ALAMEDA COUNTY
HEALTH CARE SERVICES

Subject: SLIC Case RO0002567, Chung Property, 2942 San Pablo Avenue, Oakland, CA – Work Plan Approval

Alameda County Environmental Health (ACEH) staff has reviewed the Spills, Leaks, Investigations, and Cleanups (SLIC) case file for the above-referenced site and the document entitled, "Addendum to Work Plan for Additional Site Characterization and Report of Well Survey," dated April 27, 2006. The Addendum addresses ACEH's April 7, 2006 technical comments on the proposed scope of work. We generally concur with the proposed scope of work in the April 27, 2006 Work Plan Addendum provided that the technical comments below are addressed during the field investigation.

Figure 4 - Proposed Surficial Sample Points - Metals

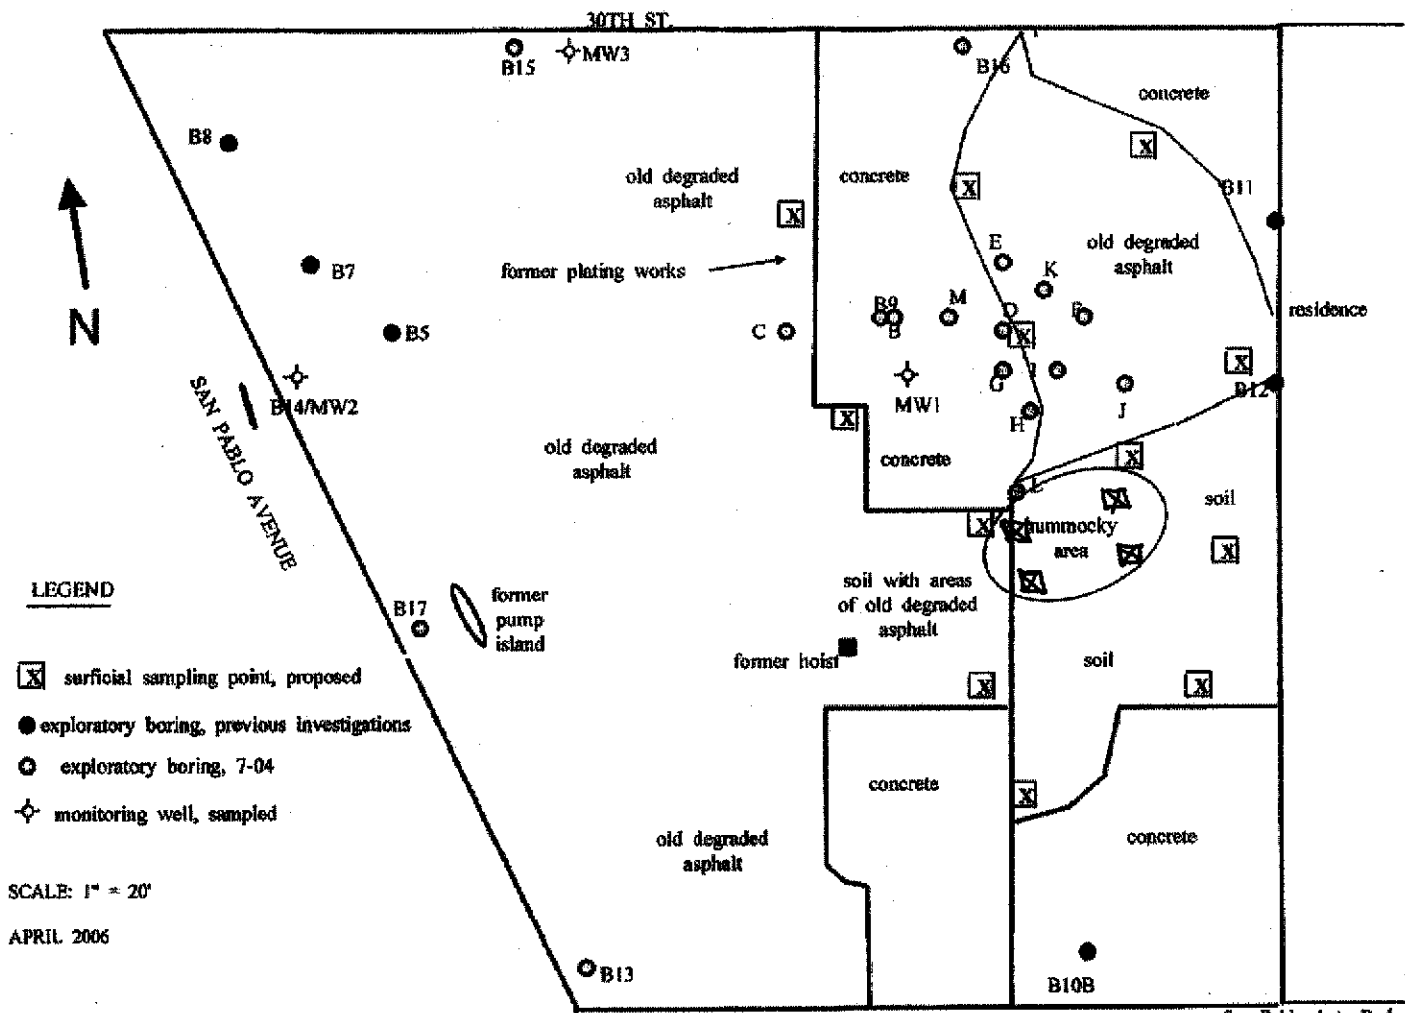
- 2. Soil Sampling for Metals and Cyanide.** In addition to the proposed twelve soil sampling locations, we request that four soil samples be collected from the hummocky area as shown on the attached figure, "Requested Surficial Soil Sampling Locations." When compositing soil samples in the laboratory, please assure that the four requested soil samples from the hummocky area are composited into one sample. If any analytes are detected at concentrations exceeding the Environmental Screening Levels, each of the discrete soil samples is to be analyzed.

Requested Surficial Soil Sampling Locations

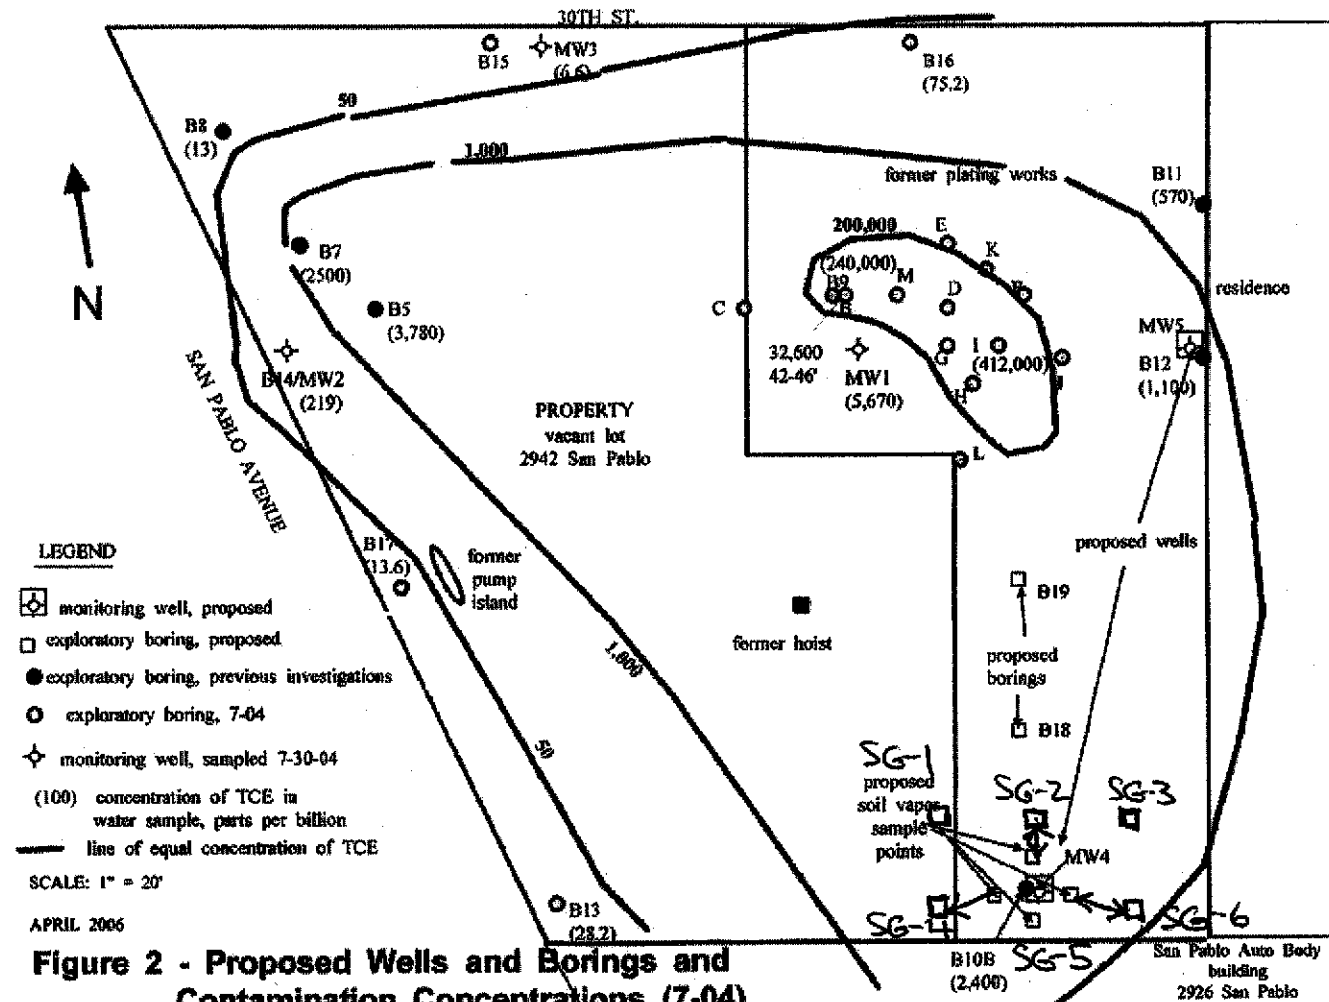
- 1. Soil Vapor Sampling near Boring B10B.** The Addendum proposes four soil vapor samples approximately 5 feet apart surrounding boring B10B. The purpose of the soil vapor sampling is to assess whether a source exists within the area of boring B10B. Therefore, we request that soil vapor samples be collected from six locations on a grid in the area around boring B10B as shown on the attached figure entitled, "Requested Soil Vapor Sampling Locations." We also request that soil vapor sampling be continued as necessary to define the extent of the source area if elevated concentrations of volatile organic compounds (VOCs) are detected in any of the soil vapor samples. The proposed methods for collecting the soil vapor samples are acceptable. Soil gas samples are to be analyzed for VOCs using EPA Method TO-15.
